**NOTICE OF PLANNING & ZONING COMMISSION SPECIAL MEETING**

RE: Kum & Go 0198 – Site Plan Submittal #3

SITE PLAN DRAWINGS  
STORE #0198  
I-35 & CUMMING AVENUE  
CUMMING, IA 50061

**PUBLIC IMPROVEMENT DRAWINGS**  
**STORE #0198**  
**I-35 & CUMMING AVENUE**  
**CUMMING, IA 50061**

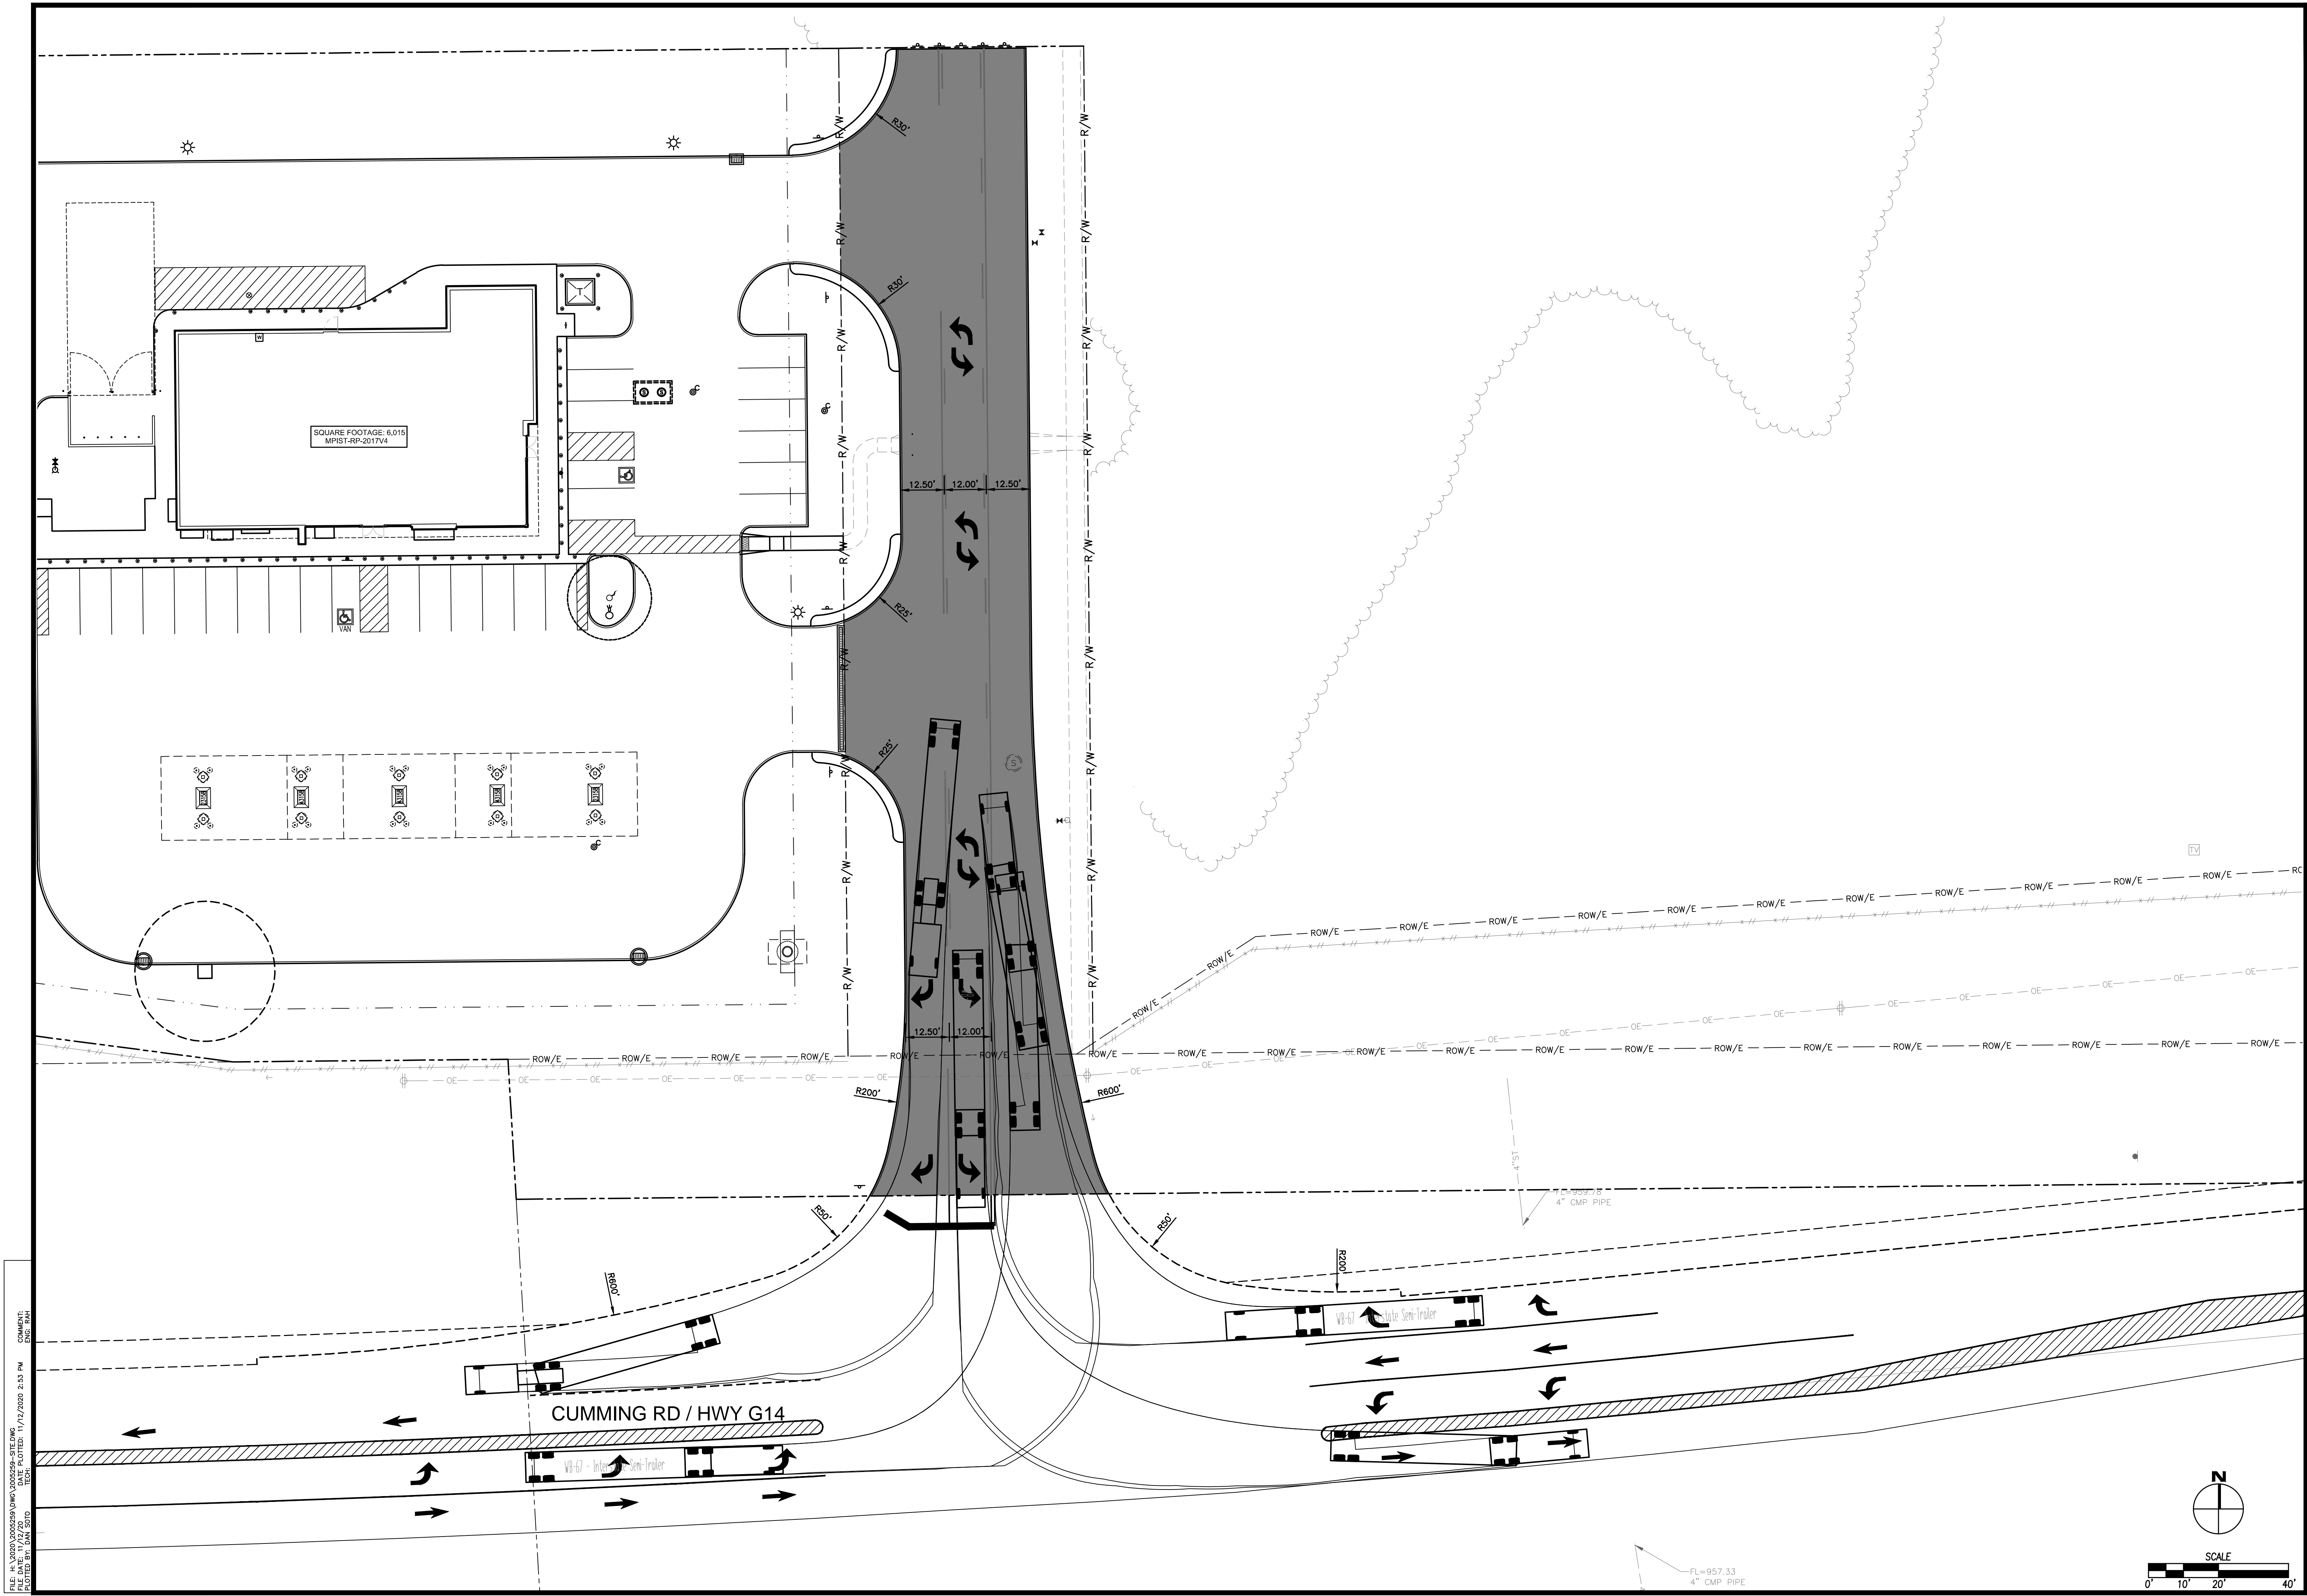
1. As shown on the "Autoturn Exhibits" the turning radii of the trucks northbound from the east, and southbound to the west, closely hug the edge of the intersection pavement. The pavement radii should be increased to have a clearance of 2 feet between the vehicle and the edge of pavement.

**The offset and intersection have been revised to provide more clearance (see attached turning movement exhibit).**
